SS 3123 - FTL 2023 P4 New Cascadia Web Mounted 5th Wheel Ramps

Freightliner New Cascadia vehicles equipped with Holland air sliding 5th wheels (Family Data Code 578-A02) and frame rail web mounted ramps.

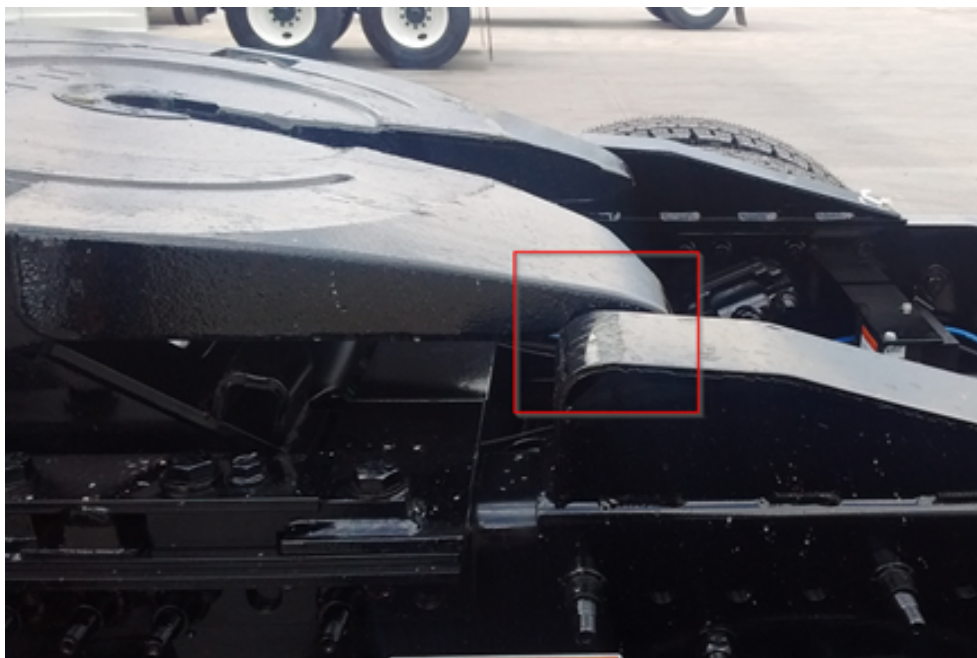
On certain tractor configuration vehicles, when the 5th wheel is slid aft, there is potential for the 5th wheel top plate to contact the 5th wheel ramps. This interference restrains the 5th wheel top plate from reaching the designed lowest position when the tractor is in the unloaded configuration. (See picture below).

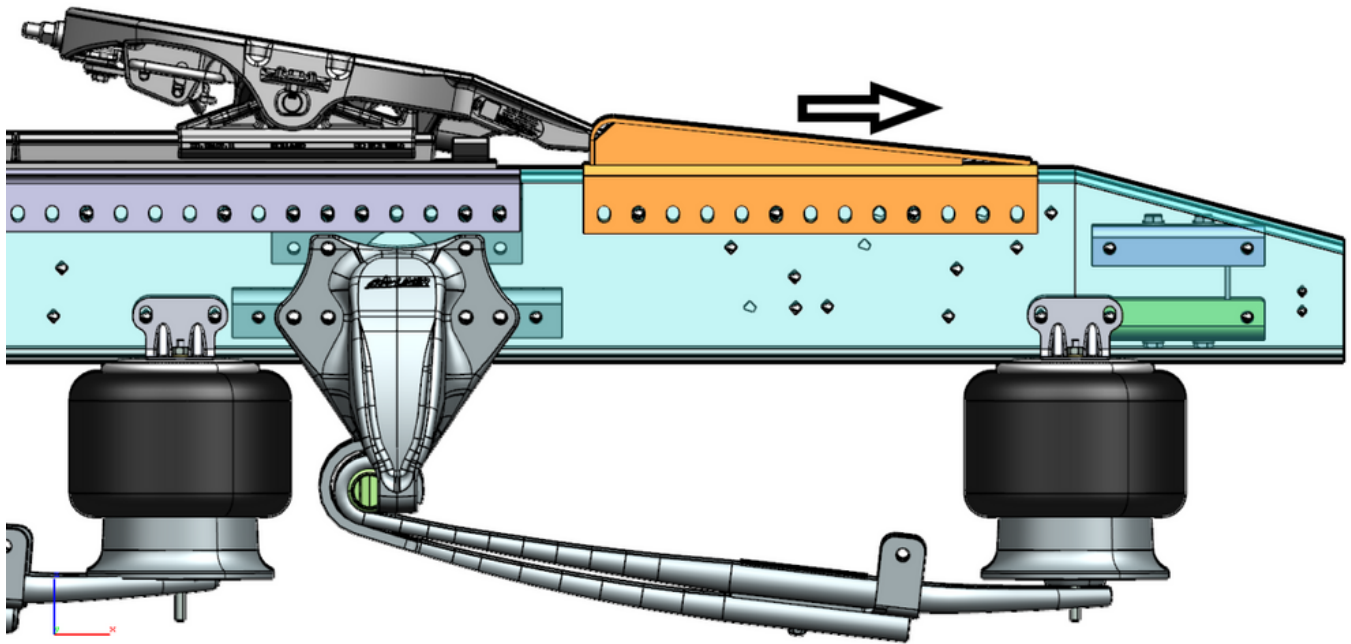
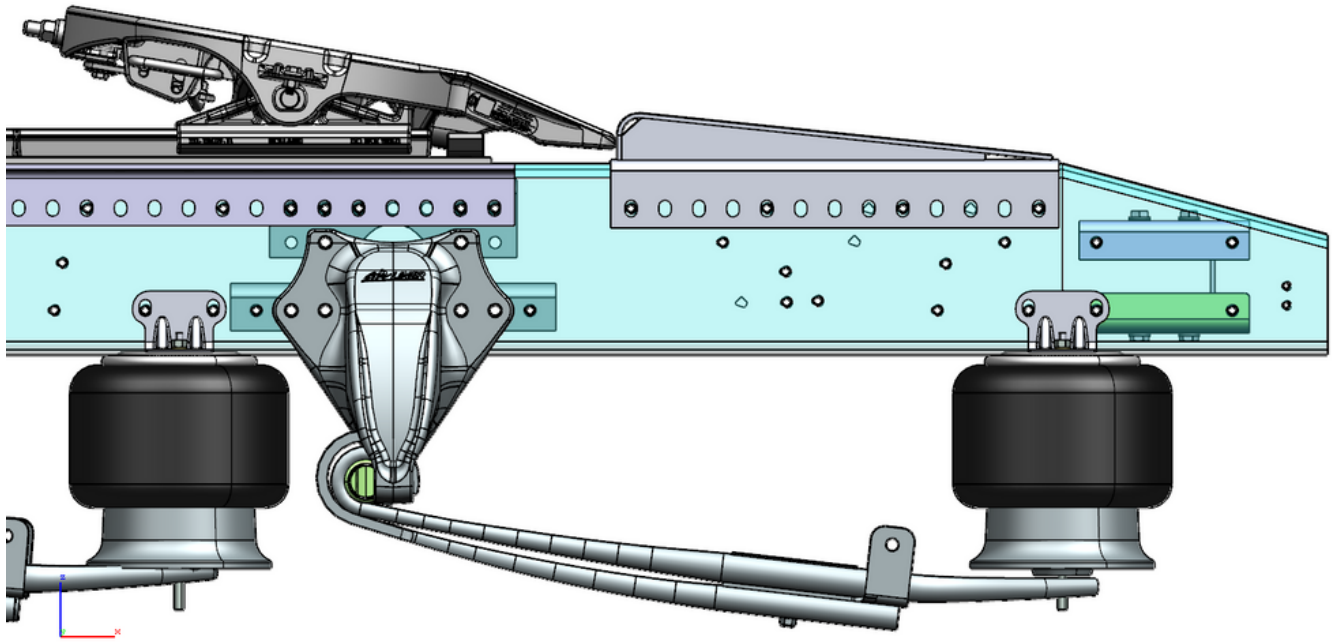
To avoid the symptoms reported above, web mounted 5th wheel ramps were modified at the truck manufacturing plant. A potential interference issue is possible when a dealer/customer orders new unmodified replacement 5th wheel ramps.

- Move the replacement 5th wheel ramps one frame rail grid hole aft to provide the required clearance. (See pictures below)
- If moving the replacement 5th wheel ramps one frame rail grid hole aft is not possible, modify the replacement ramp width to provide required clearance to the 5th wheel top plate. Use the width of the original factory installed ramps as a guide for the modification required.
